UNITED STATES PATENT AND TRADEMARK OFFICE

APPLICATION NO.	FILING DATE	FIRST NAMED INVENTOR	ATTORNEY DOCKET NO.	CONFIRMATION NO.
10/726,601	12/04/2003	Chih-Min Chang	CHAN3234/EM	6965

Office Action Summary	Application No.	Applicant(s)	
	10/726,601	CHANG, CHIH-MIN	
	Examiner	Art Unit	
	Hadi Shakeri	3723

DETAILED ACTION***Claim Rejections - 35 USC § 102***

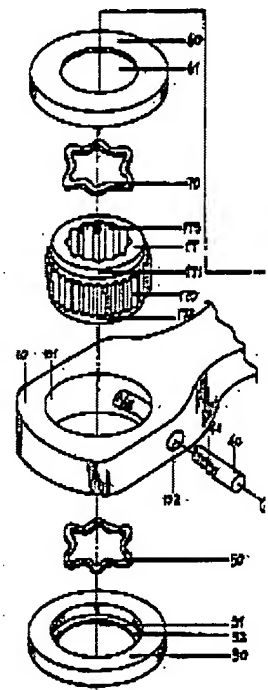
2. Claims 1-3, 5 and 6 are rejected under 35 U.S.C. 102(b) as being anticipated by Lee (4,991,468).

Lee discloses all of the limitations of claim 1, i.e., a ratchet wrench including a handle having a hole at an end thereof; a ratchet wheel (17) having a polygonal hole at a center thereof, a first teeth portion at an annular outer surface thereof, and two engagement portions (171) (172) disposed respectively at opposite ends thereof; said ratchet wheel being rotatably mounted in the hole of the handle with the engagement portions protruded out of the hole of the handle; a pawl (40) mounted in the hole of the handle and having a second teeth portion detachably meshed with the first teeth portion of the ratchet wheel, and two annular members (30) (60) firmly fastened to the engagement portions of the ratchet wheel respectively, said annular member each having an outer diameter greater than a diameter of the hole of the handle.

Regarding claims 2 and 3, Lee meets the limitations, e.g., engagement portions coaxially disposed.

Regarding claims 5 and 6, Lee meets the limitations, e.g., embossments (70) provided at a wall of the hole of the annular members and engagement portion of the ratchet wheel.

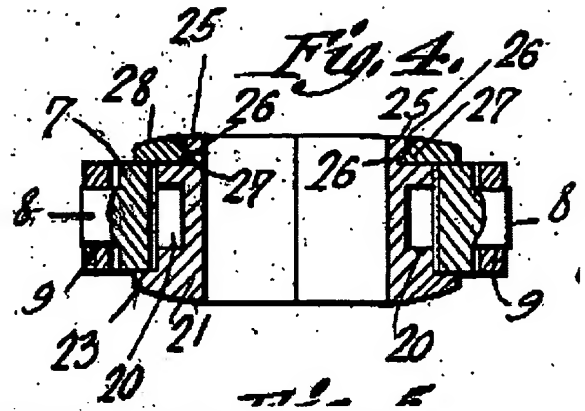
3. Claims 9-11 and 13-16 are rejected under 35 U.S.C. 102(b) as being anticipated by Cross (1,331,956).

Cross discloses all of the limitations of claim 9, i.e., a ratchet wrench including a handle having a hole (an opening through something as defined by Webster) at an end thereof; a ratchet wheel (20) having a polygonal hole at a center thereof, a first teeth portion at an annular outer surface thereof, an engagement portion (24, 25) at one end, an annular flange (23) having a diameter greater than the hole at the other end; said ratchet wheel being rotatably mounted in the hole of the handle with the engagement portion and the annular flange protruded out of the hole of the handle; a pawl (19) mounted in the hole of the handle and having a second teeth portion detachably meshed with the first teeth portion of the ratchet wheel, and an annular member (28) firmly fastened to the engagement portion of the ratchet wheel respectively, said annular member having an outer diameter greater than a diameter of the hole of the handle.

Regarding claims 10 and 11, Cross meets the limitations, e.g., engagement portions coaxially disposed.

Regarding claims 13 and 14, Cross meets the limitations as recited, i.e., "embossments" (8) and (9).

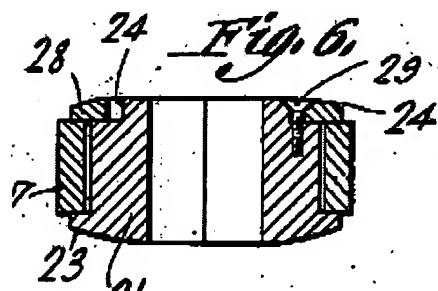
Regarding claims 15 and 16, Cross meets the limitations as recited, i.e., screw thread connection (29) and sloped surfaces (26) and (27).
